Work Order ID 126771

Item Name: Clip

ENGINEERING CHANGE NOTICE NL 04510

From: Pablo Bravo
Sent: November-18-14 1:20 AM
To: Jean-Luc Menard
Cc: Linda Lacelle; David Duval; Marc Bellavance
Subject: Re: 647.4113/647.4112 FLAT PATTERN ERROR

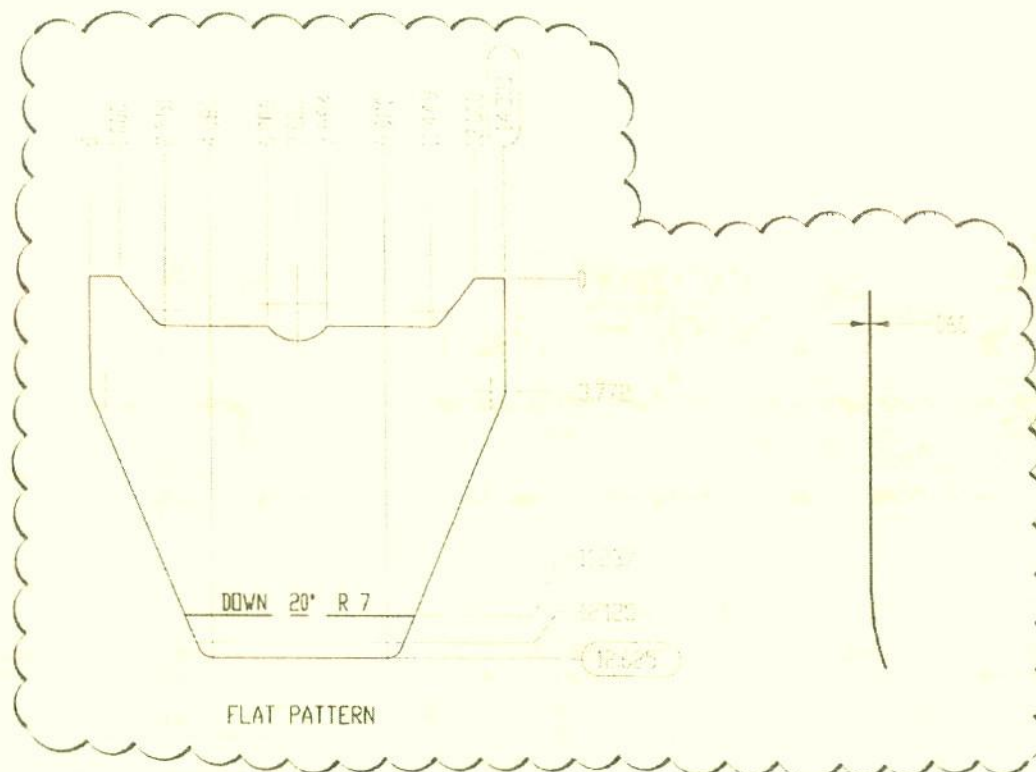
REASON: MODIFIED DOUBLER.

SHEET 1, ZONE C2 IS:

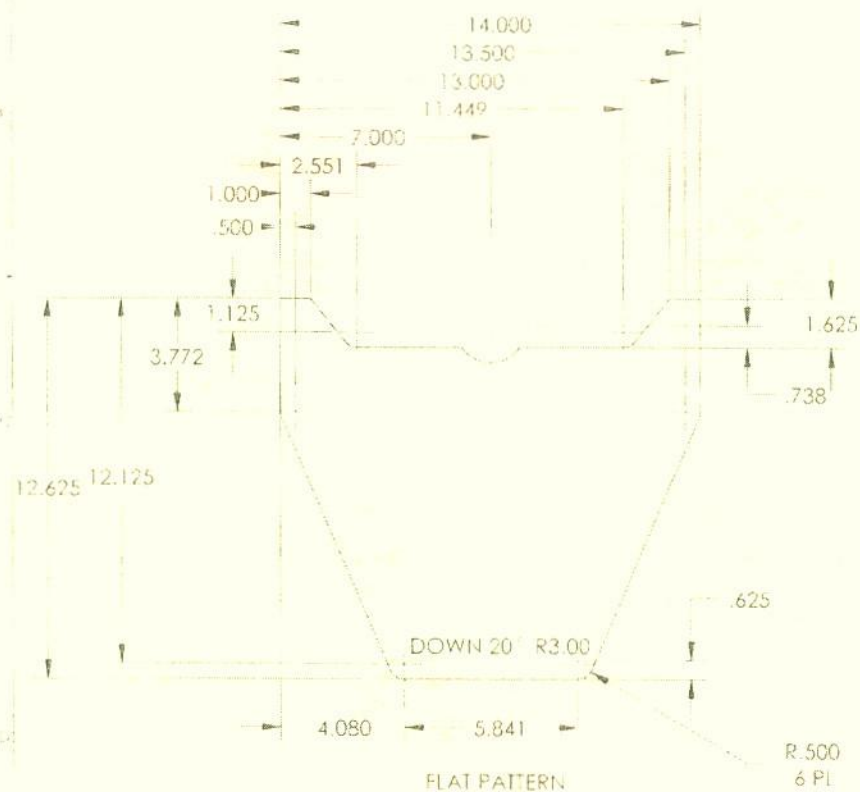
SHEET 1, ZONE A1 IS:

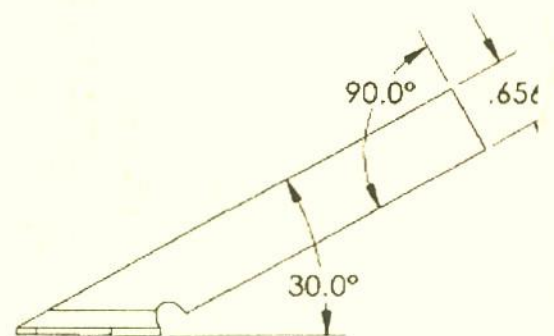
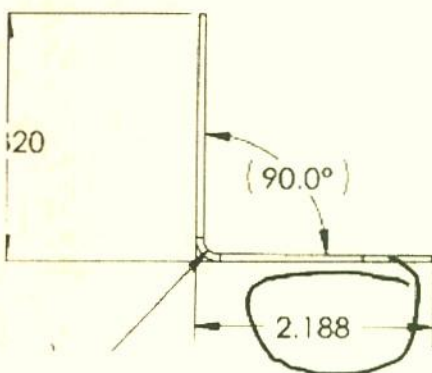
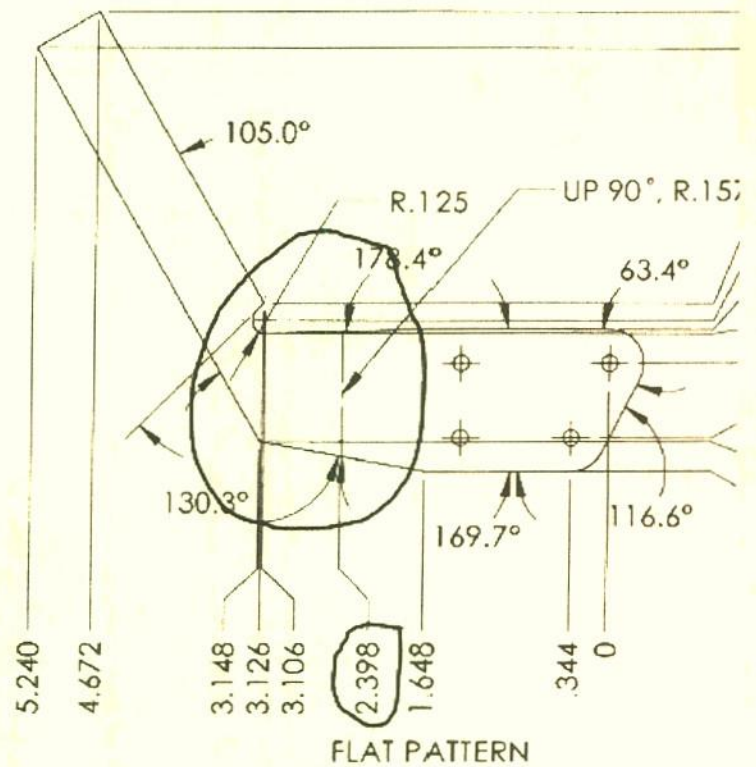
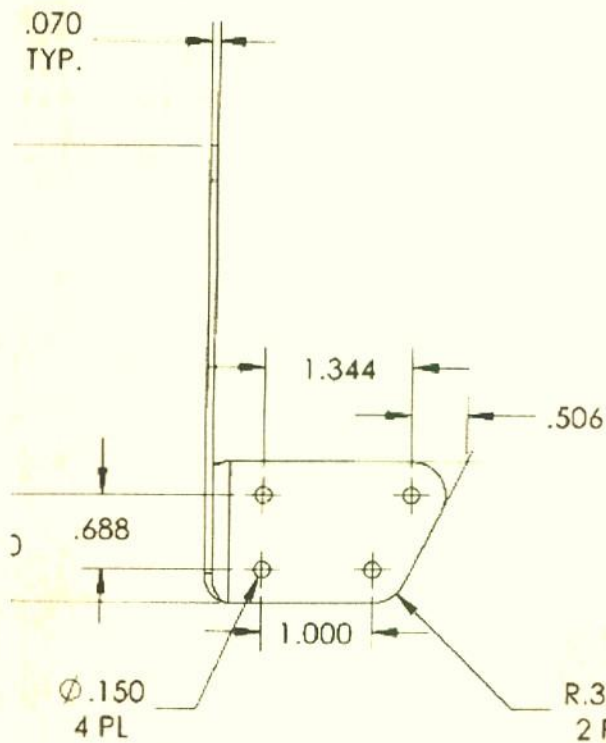
Hi Pablo,
There seems to an error in the flat pattern on the dwg, Marc Bellavance had a quick look and came up with the file attached.

What is happening is the flat pattern is too long in the mid section(see snip below).

Let me know if you need me to issue an ecr for this one, and if we can continue with Marc's updated flat pattern.

Hi Linda,
New Flat pattern has been programed and is on the network.
See below for Pablo's e-mail to attach to the w/o.
Attached is a temporary dim sheet to reflect the new dimensions.
JL

The flat pattern is acceptable. We'll need to get the drawing updated.
